## KASAI WM – LOOSE TUB SPRING

WM FL KASAI 914908xxx with serial number from 214xxxxxxx until 250xxxxxxx

Pic.1. WM example of spring jumped out

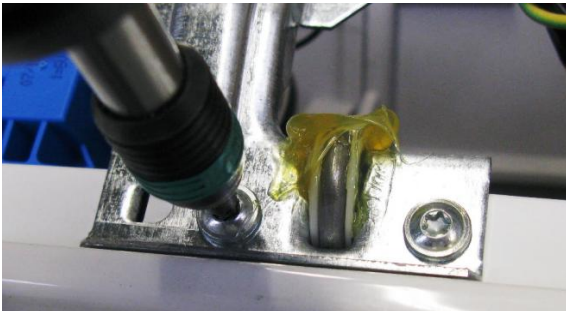
In case of improper load balancing in front loader Washing Machine under specific conditions spring may jump out of outer case support. Pic.1. show WM where spring jumped out

In cases where product exchange is no needed, service kit 4055212114 with two springs lock (for left and right side) should be used.
